**Subject** ▶ Change on field

**For Models** ▶ 6905H (Impact Wrench)

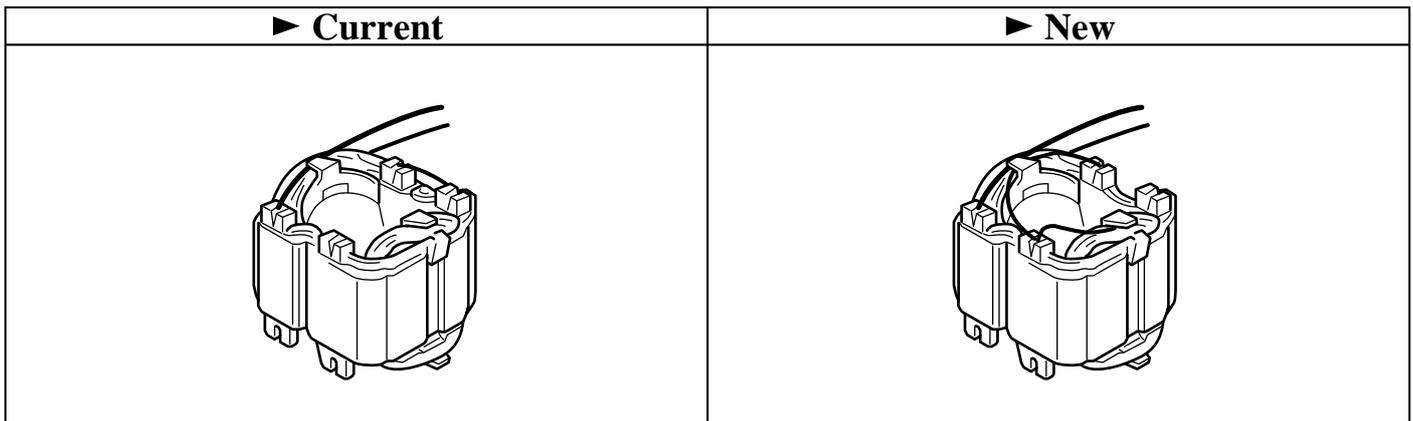
**Description** ▶ The method of connecting the field coil to the terminals will be changed as follows.

As a result, the method of connecting the lead wires to field will be changed as follows. (Note: The method of connecting the field to the switch will remain unchanged.)
